## **ADDENDUM #001**

Date: November 17, 2021

**Harwood Elementary School Reroof  
Jefferson School District No. 251  
Rigby, Idaho  
NBW Project #21008**

**G1.0**  
REVISED 11-17-2021

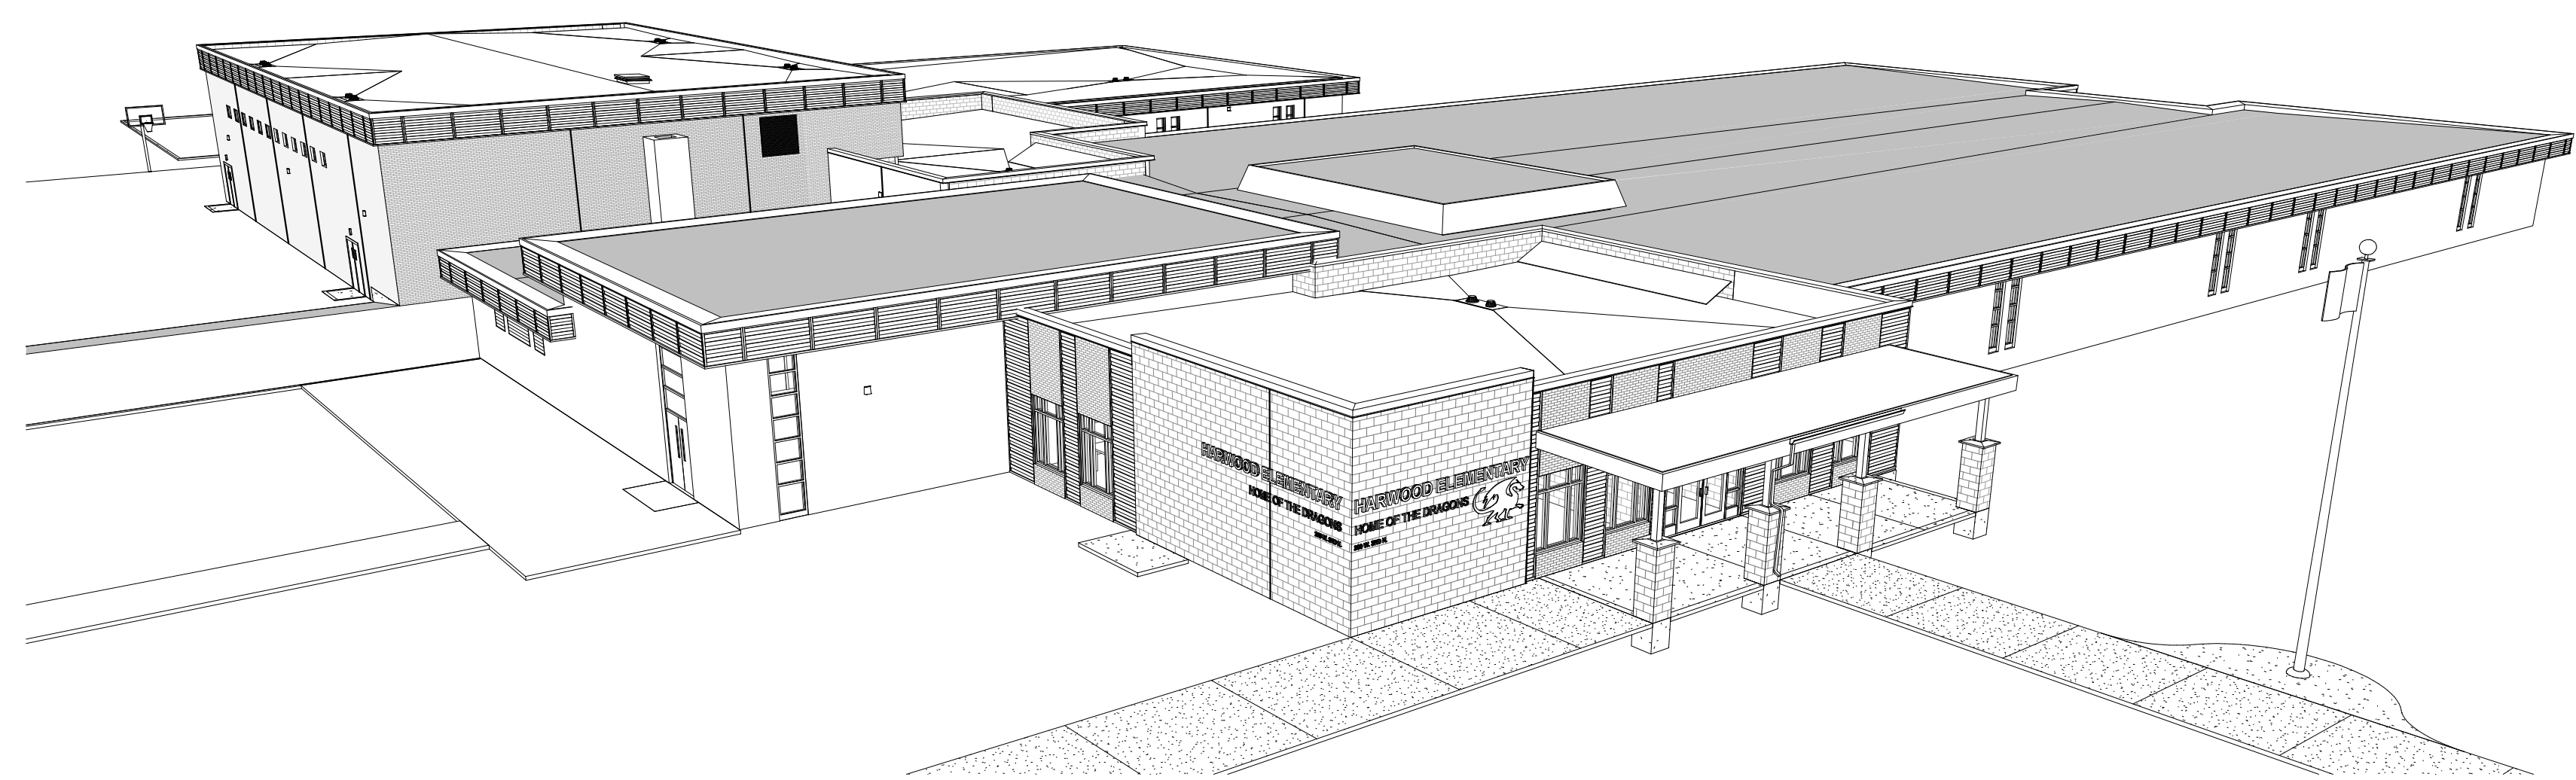
1. Sheet G1.0 – Code Analysis has been added.
2. Sheet A7.1 – Keynote 2 has been changed to note that the attic vents are to be replaced.
3. Sheet A7.2 – Keynote 10 has been added for the replacement to the attic vents.
4. Sheet A7.2 – Detail 3 has been revised to place the substrate board below the roof membrane.
5. Sheet A7.3 – Insulation has been added to complete the thermal barrier.
6. Sheet A7.3 – Detail E has been revised to include fastening at the changes in plane.
7. Sheet ME1.1 – DBS review notes have been added.
8. Sheet ME1.2 – DBS approval stamp has been added.

CODE ANALYSIS	
<b>CODE ANALYSIS</b>	
BUILDING/STRUCTURAL:	2018 IBC
ELECTRICAL:	2017 NEC
PLUMBING:	2017 IPC
MECHANICAL:	2018 IMC
<b>CONSTRUCTION TYPE:</b>	
TYPE V-B, NON FIRE SPRINKLED	
<b>BUILDING OCCUPANCY:</b>	
E- EDUCATIONAL	
<b>AREA BY OCCUPANCY GROUP:</b>	
EXISTING BUILDING	33,897 FT <sup>2</sup>
<b>BUILDING INFORMATION:</b>	
HEIGHT OF BUILDING:	27'-0"
NUMBER OF STORIES:	SINGLE LEVEL
<b>ATTIC VENTILATION:</b>	
PER 2018 IBC SECTION 1202.2.1 VENTILATION REQUIRED TO BE 1/150 OF VENTILATED SPACE.	
TOTAL VENTILATED SPACE:	34,000 FT <sup>2</sup>
TOTAL REQUIRED VENTILATION:	227 FT <sup>2</sup>
TOTAL VENTILATION:	22 ATTIC VENTS @ 4 FT <sup>2</sup> EACH: 88 FT <sup>2</sup>
	SOFFIT VENTS @ 360 FT <sup>2</sup>
TOTAL VENTILATION > TOTAL REQUIRED VENTILATION
